Delegate Assessment Report

File Number: DA2861
Planning Application No. P231/22
Responsible Officer: Nicole Embling, Coordinator Statutory Planning

<i>Application Details</i>	
APPLICANT	Mr Sam Zito Invo Design
PROPOSAL	Use and development of land for an Exhibition Centre (Motor Car Museum) and Restaurant (Café), development of land for Warehouses, display of business identification signs, reduction of car parking requirements, removal of native vegetation (5 trees) and creation of an easement
APPLICATION LODGED	28 November 2023 Application amended – 6 June 2023 To include the removal of native vegetation Application amended – 6 July 2023 To include the creation of an easement
NOTICE AND SUBMISSIONS	12 April 2023 – 4 May 2023 The application was advertised to neighbouring owners and occupiers, a sign was placed onsite, and an advert was in the local newspaper. Following conclusion of the notice period one (1) submission was received. 7 June 2023 – 28 June 2023 The application was advertised to neighbouring owners and occupiers. Following conclusion of the second notice period no submissions were received.

<i>Property Details</i>	
PROPERTY ADDRESS	255 Dead Horse Lane, Mansfield
LA

Figure 5: Landscaping Plan

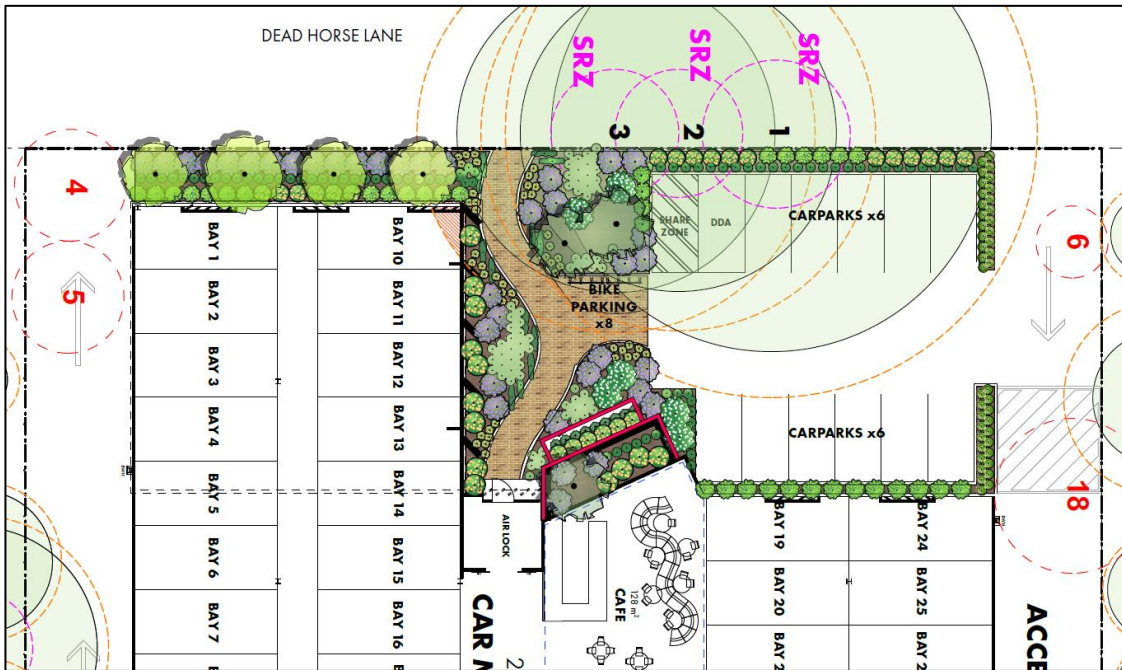
The submitted application is supported by a landscaping plan which provides for significant plantings along the southern (Dead Horse Lane) property boundary and will partially screen the proposed buildings from the existing dwellings on Dead Horse Lane.

The application is supported by a complete Landscaping Plan which provides detailed design at the frontage of the site to separate the Museum building from the road and for partial visual buffers for the car park. Additional pocket landscaped areas are proposed at the front of each Warehouse. The landscaping proposed is considerate of the proposed built form and will compliment the surrounding landscape, including the large existing native trees along Dead Horse Lane.

10. The landscaping shown on the endorsed plans must be maintained in good condition to the satisfaction of the Responsible Authority, and any dead, dying, diseased or damaged plants are to be replaced with like for like replacements of the same or greater size.

Figure 8: Sign proposal for Car Museum

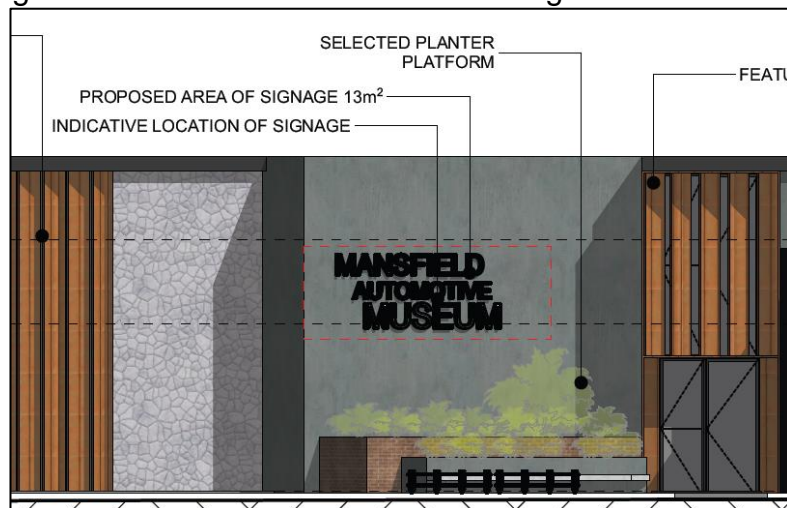
The submitted Planning Report and relevant plans propose Business Identification Signs of 13sqm for the Car Museum and 17sqm for each Warehouses.

The location of the sign for the Car Museum is set on an angled wall and is of a minimalist design.

4. The signs must not be illuminated by external or internal light. The Responsible Authority may consent in writing to vary this requirement.
5. The signs, including the structure and content, must be constructed and maintained to the satisfaction of the Responsible Authority.

Figure 9: Sign proposal for each Warehouse

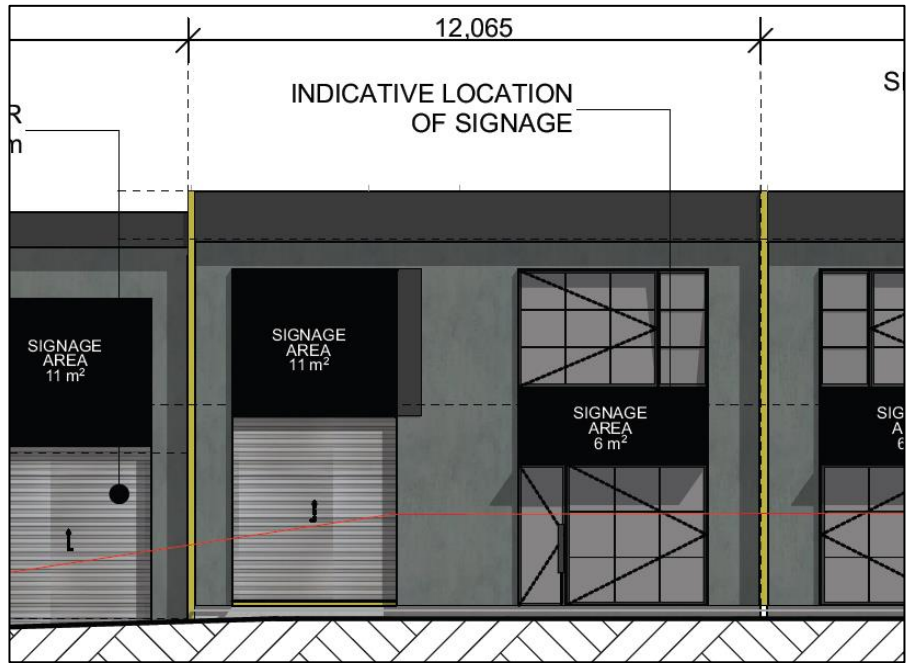
Similarly, the signs for each Warehouse have allocated areas which face the east and west boundaries and will not be visible from the public realm.

Overall the submitted signs are considered appropriate.

Figure 10: NVRR

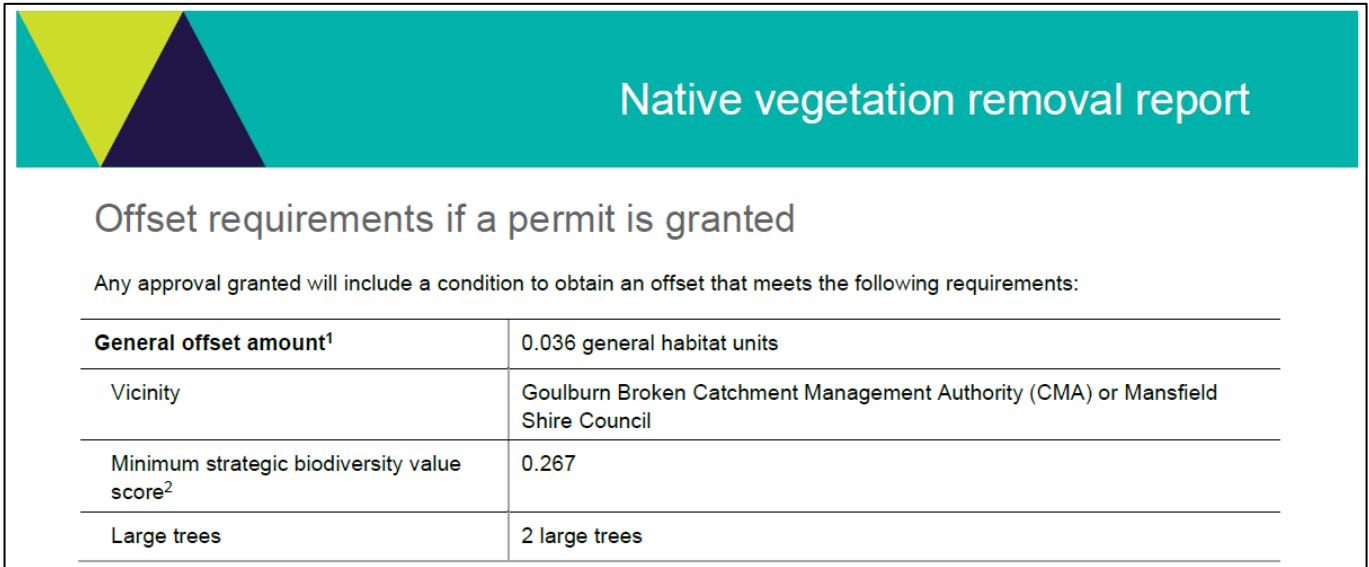
As discussed in this report, a NVRR has been prepared and submitted with the application, which details an appropriate offset amount that meets the offset requirements for the native vegetation to be removed has been identified and can be secured in accordance with the Guidelines, as per the following:

Offset requirements will be a condition of permit. Overall, the proposal is considered to be generally in accordance with the requirements of this provision.
